## Product Change Notification

1. ECN #: 260944

- SMP - SMP ST JACK FOR RF25S CABLE - 50 OHM

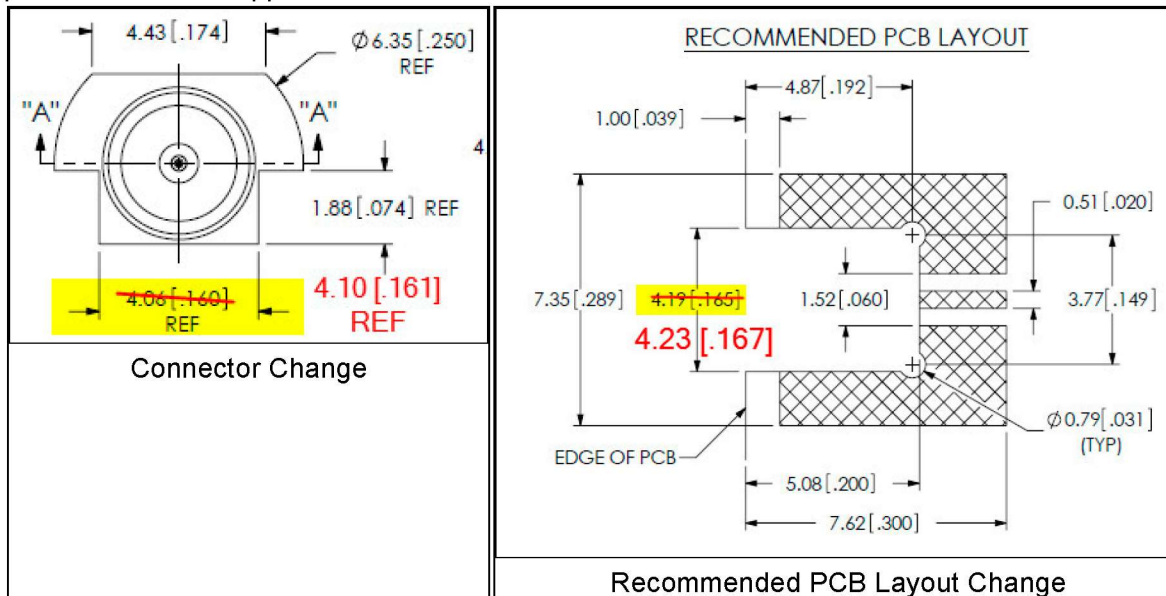
The print is being updated to better reflect how product is being shipped. The portion of the connector which rests inside a cutout on the board increases from 4.06mm to 4.10mm on the print. The recommended PCB layout connector cutout region being suggested changes from 4.19mm to 4.23mm to account for the adjusted connector width.

Product has generally been built towards to upper end of the 4.06mm specification to avoid a thin wall condition near the interface. The print is being updated to better reflect how actual product is being built and the recommended PCB layout is adjusted to account for this increase.

- Fit - The portion of the connector which rests in the PCB cutout increases from 4.06mm to 4.10mm.
- Fit - The recommended PCB layout cutout region increases from 4.19mm to 4.23mm.
